Pines Dining Hall + Servery Addition

Northern Health Authority

Addendum No. 2

DGBK Project No. 17-110

A-401

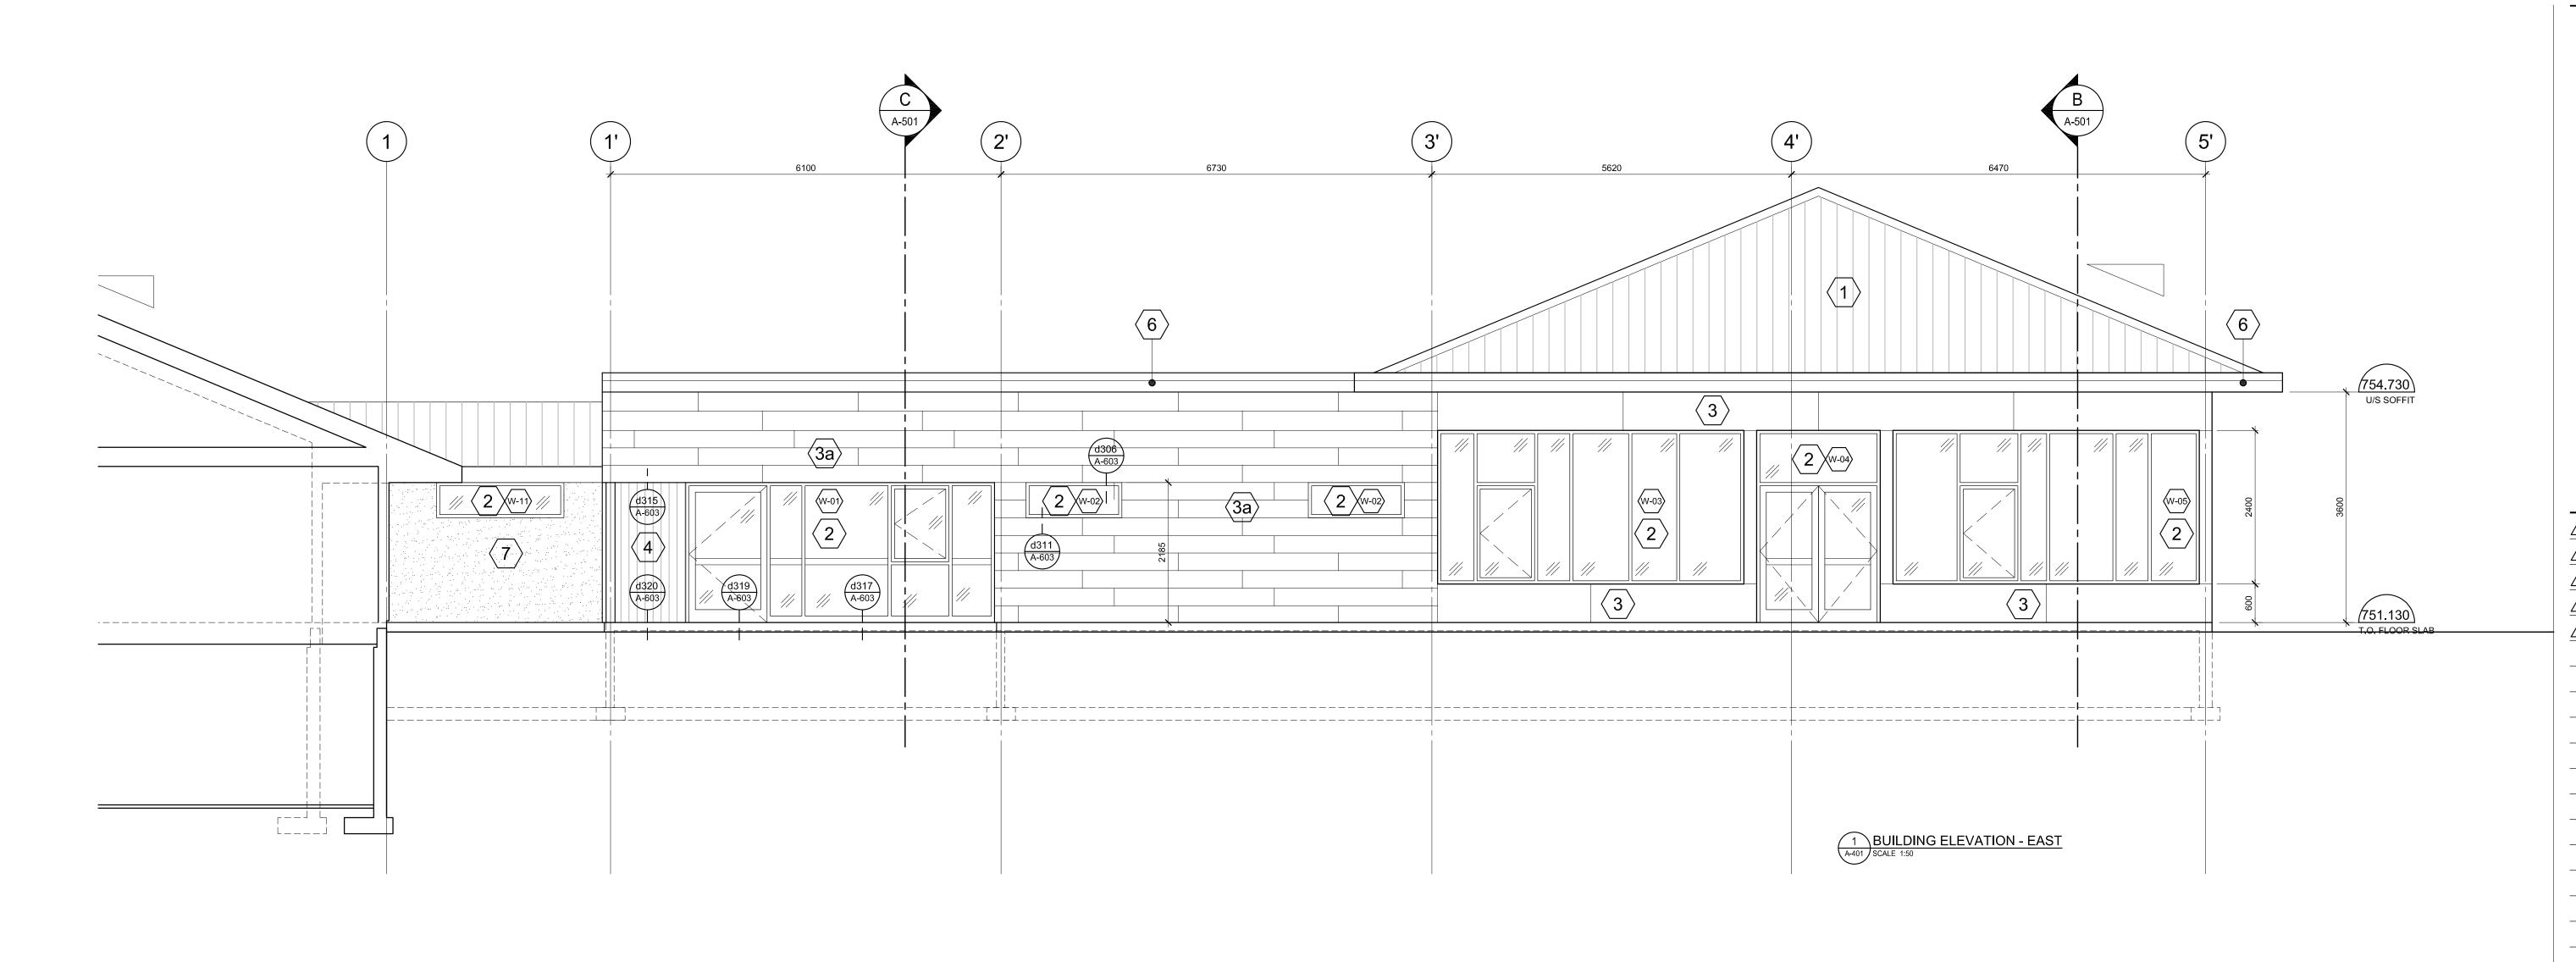
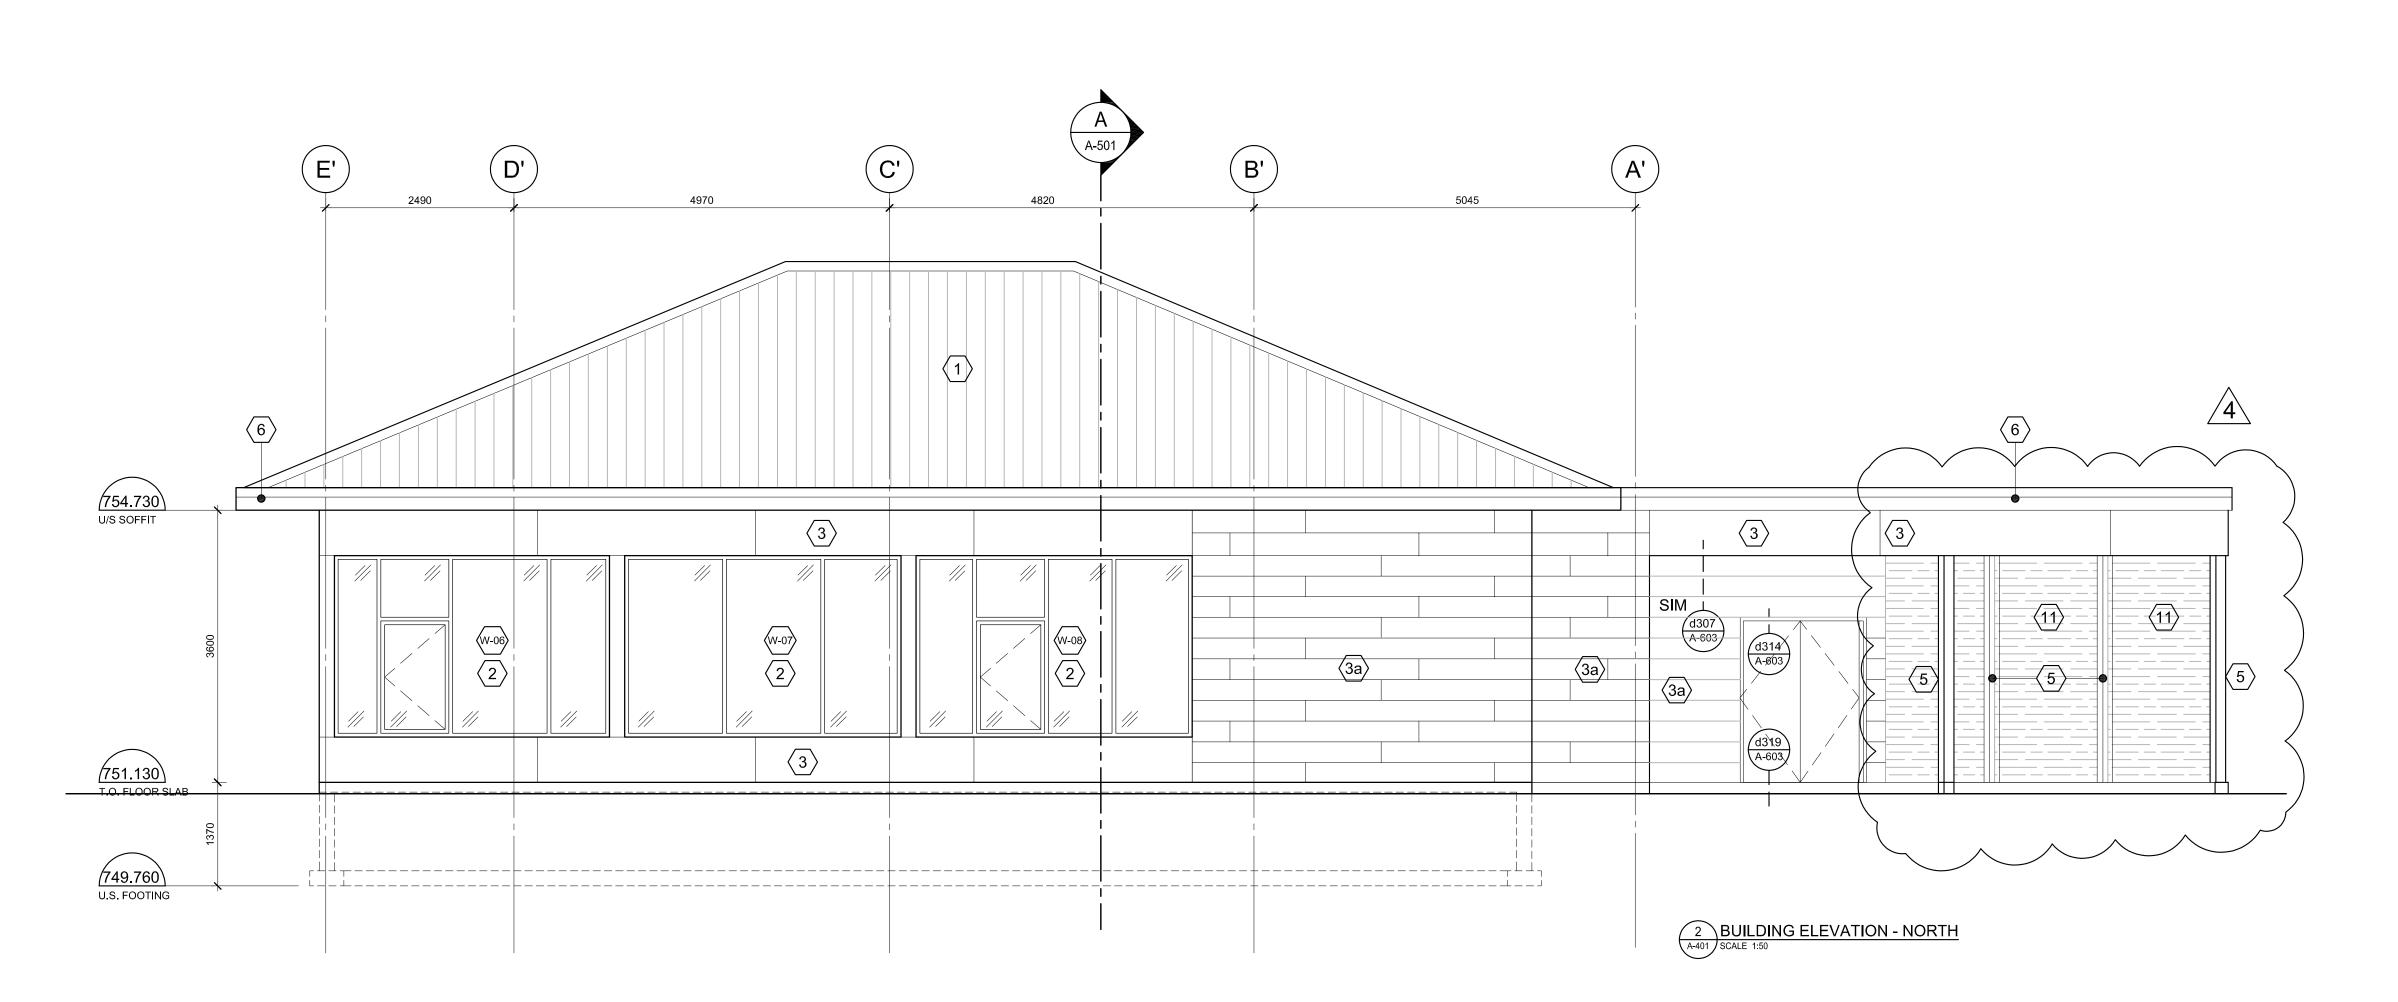
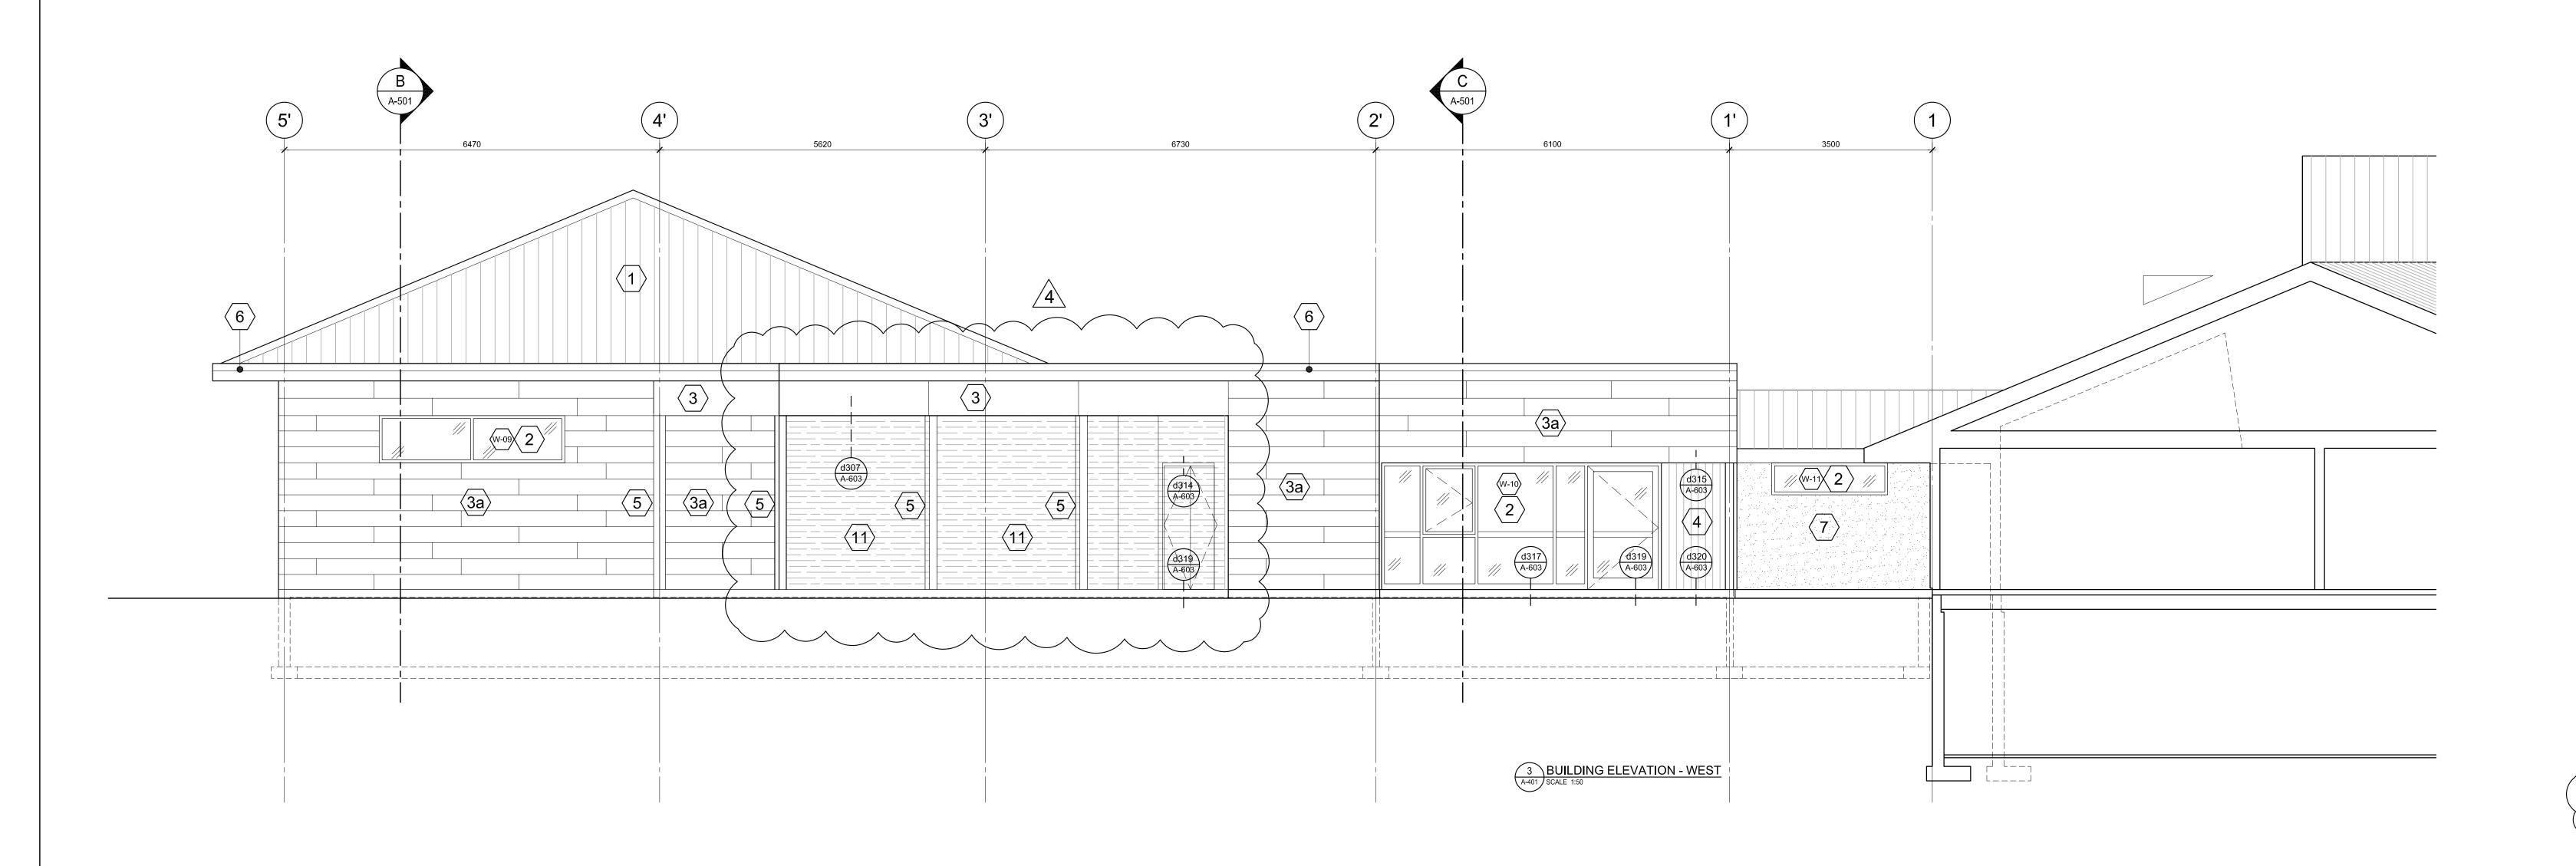
2. Extent and layout of Polycarbonate infill Panels in Loading Bay area.

ASK-002

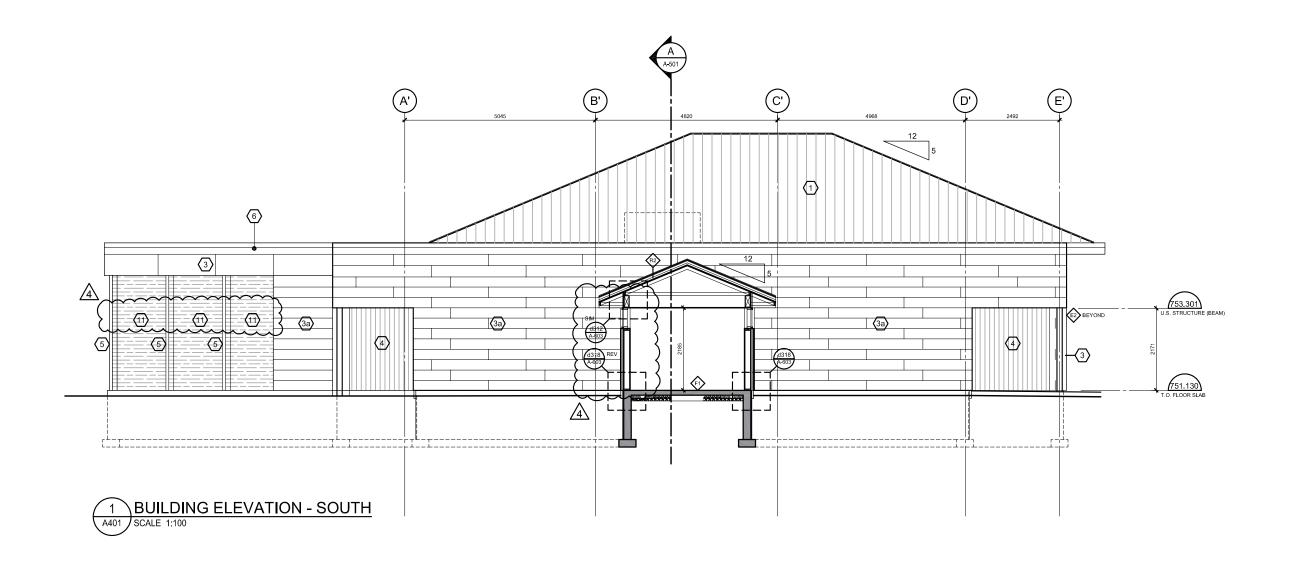
Code Analysis Section 2.4 delete last line "There will be no additional fire...".

BUILDING SECTION A

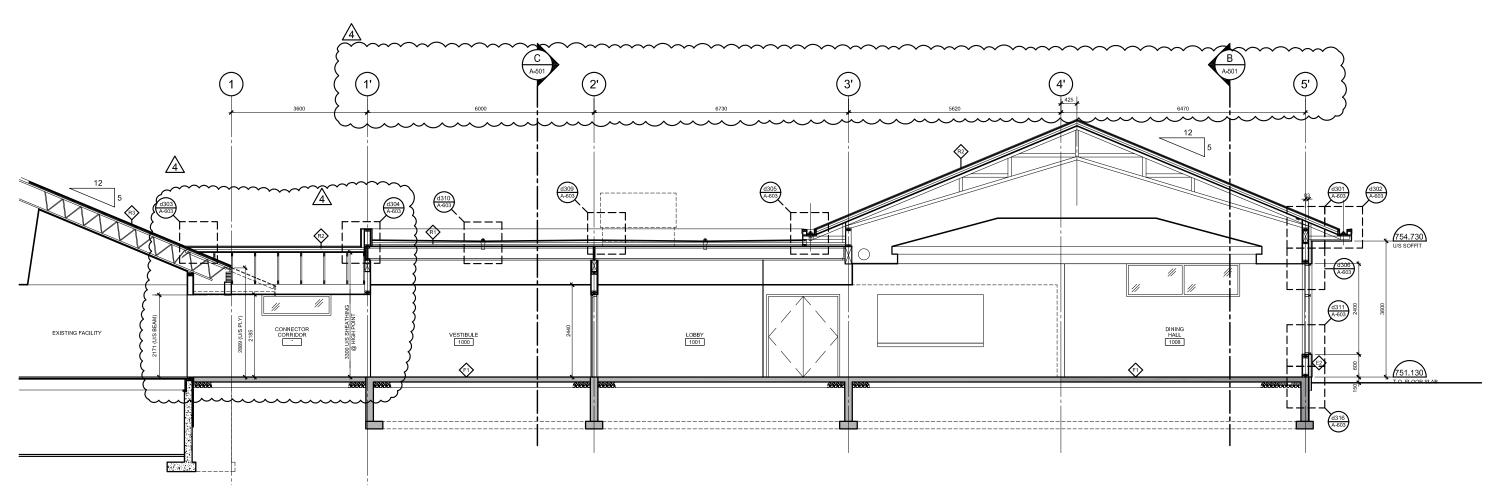
Note the following addition to Building Section A (1/A-501).

- 1. Building Detail Tag have been updated to read: d303/A-603
- 2. Building Grid Line Tags have been revised to reflect plan tags.
